Service Instructions SP030/03/I

Title: Main Inverter Interference Suppression

Chg. Ref. No.: 127507 / 130945
 Name: Gyönyör
 Dept.: CS PS 24

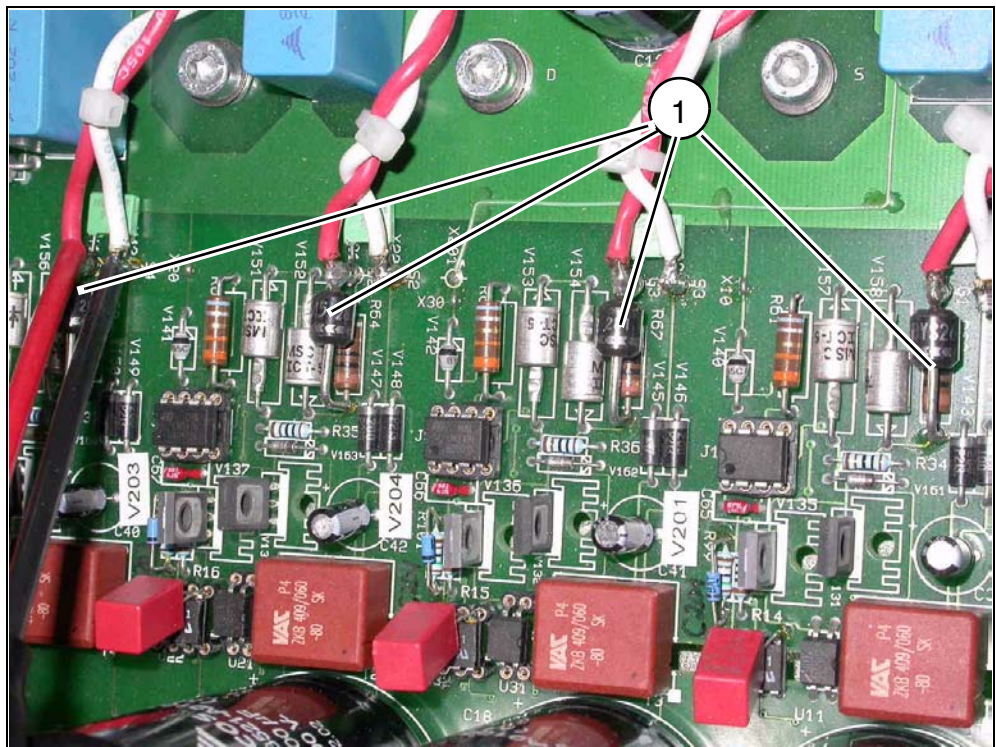
1. Remove the four diodes V301 ... V304 as described here.

They are not marked on the board but are located above the Resistors R62, R63, R64 and R67. See 1/Figure 1.

Fig. 2

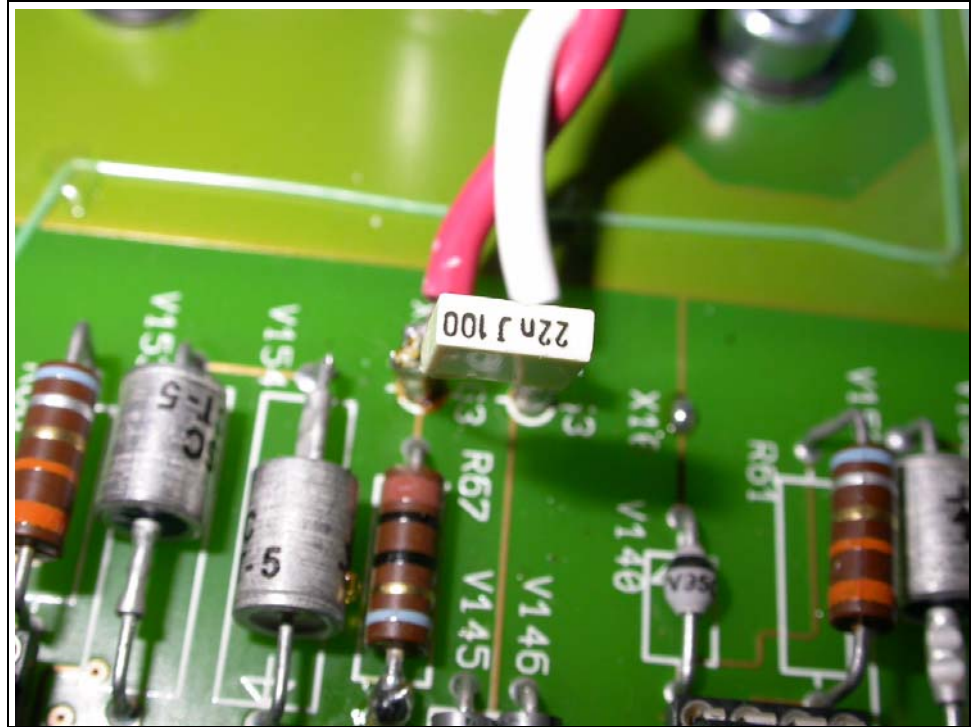
2. **Exchange the 22nF gate capacitors C301 - through - C304 with the supplied 100 nF capacitors, material no: 7751001.**

They are not marked but located across the lugs where the wires from the power modules are normally attached. See Figure 2.

- Re-attach the 4 pairs of leads from the power modules exactly as they were before.

Fig. 3

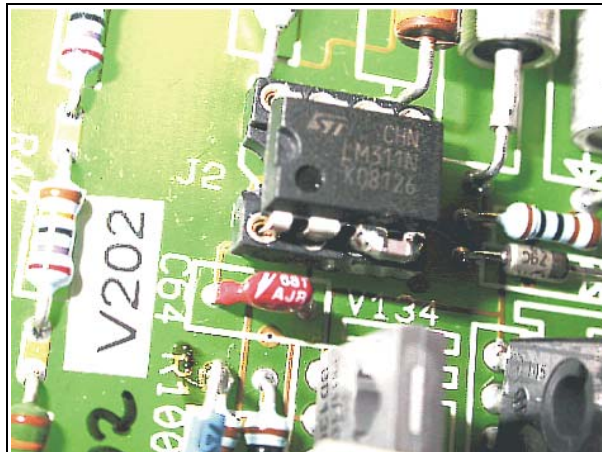
3. **Exchange the comparators Type LM311, denoted as J2, J3, J5 and J1 (marked so from left to right on the built-in D710) for the supplied ones.** On those comparators note the Surface-mounted device (SMD) capacitors 30 86 865 soldered between pins 3 and 4, see Figure 3.

4. With these changes the D710 has been transformed to the Revision level 02

Fig. 5

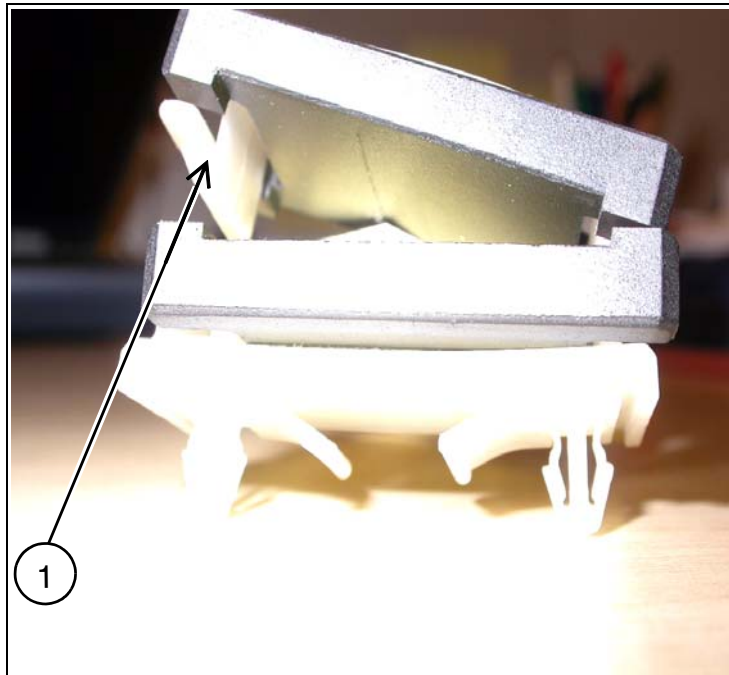
C) Application of the ferrite core**7. Affix the supplied hinged ferrite core.**

Place the ferrite - material no: 4685756 - around the ribbon cable near to the connector X2 at the inverter board D710.

For placement see Figure 4, for opening the hinged core see 1/ Figure 5.
